TECHNICAL SERVICE BULLETIN

72-A-6

ENGINE OIL CAPACITY

MGB

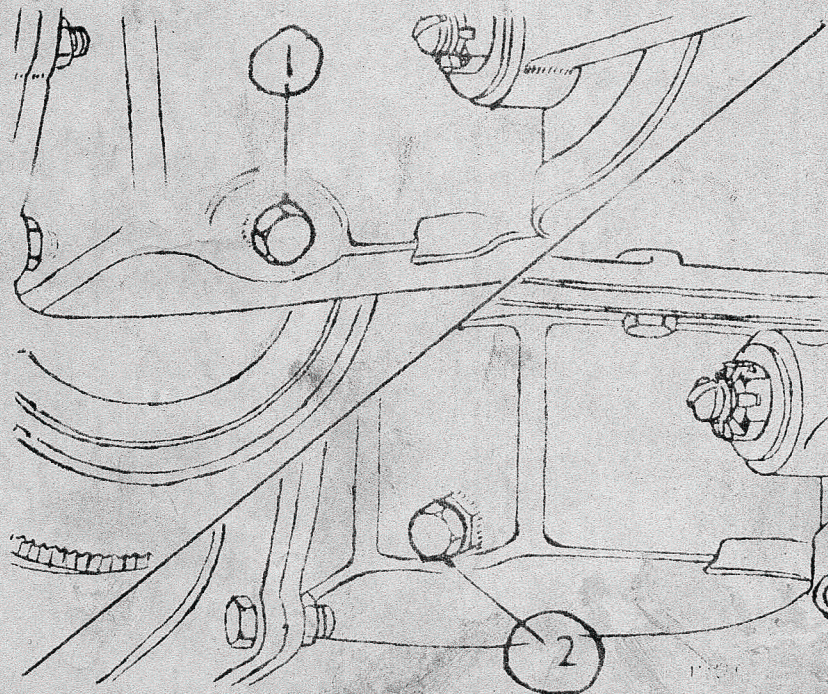
During the latter part of 1971, A MODIFIED ENGINE SUMP WAS fitted which reduced the engine oil capacity on this model by approximately 1 1/2 U.S. pints. In order to clear UP ANY misunderstanding, the following capacities are applicable:

<u>Early Type Sump</u>		<u>Modified Sump</u>
Engine:	8.5 U.S. Pints	Engine:	6.9 U.S. Pints
Oil Filter:	0.6 U.S. Pints	Oil Filter:	0.6 U.S. Pints
Oil Cooler:	0.9 U.S. Pints	Oil Cooler:	0.9 U.S. Pints

The old versus the new type sumps are shown below in illustrations 1 and 2, respectively.
